Project	IEEE 802.16 Broadband Wireless Access Working Group < http://ieee802.org/16 >	
Title	Enable closed-loop MIMO channel estimation using partially beamformed midamble/pilot	
Date Submitted	2004-11-16	
Source(s)	Qinghua Li, Xintian Eddie Lin, Shilpa Talwar, Intel Corporation	qinghua.li@intel.com Voice: +1-408-765-9698
Re:		
Abstract	Enable closed-loop MIMO channel estimation using partially beamformed midamble	
Purpose	Adoption of proposed changes into P802.16e Crossed out indicates deleted text , <u>underlined blue indicates new text change to the Standard</u>	
Notice	This document has been prepared to assist IEEE 802.16. It is offered as a basis for discussion and is not binding on the contributing individual(s) or organization(s). The material in this document is subject to change in form and content after further study. The contributor(s) reserve(s) the right to add, amend or withdraw material contained herein.

Enable Closed-Loop MIMO Channel Estimation Using Partially Beamformed Midamble

Substitute Figure 252c with

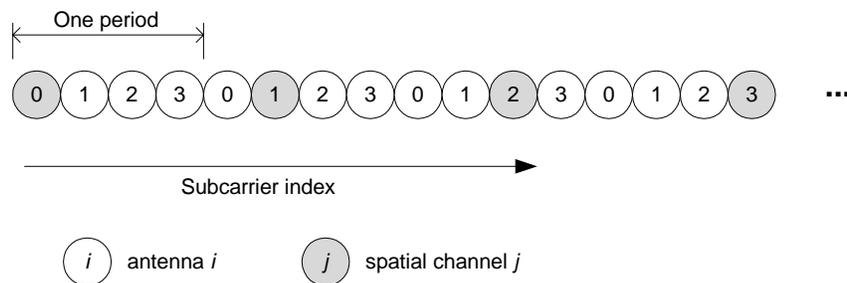
3.1 Beamforming Midamble

Modified line 6 and 7 in section 8.4.8.5 on page 245 of [1] as follows

~~The MIMO midamble consists of one OFDM symbols which is mapped onto multiple antennas. Non-overlapping subcarriers are allocated to the transmit antennas.~~

The MIMO midamble consists of one OFDM symbols which is mapped onto multiple antennas. Non-overlapping subcarriers are allocated to the transmit antennas and spatial channels. The (mN_t+j) -th subcarrier is allocated to the j -th beamformed spatial channel, where j is spatial channel index $(0, 1, \dots, N_t)$ and m is an integer starting from 0. The rest of the subcarriers are allocated to transmit antennas as follows. The (mN_t+n) -th subcarrier is allocated to the n -th antenna.
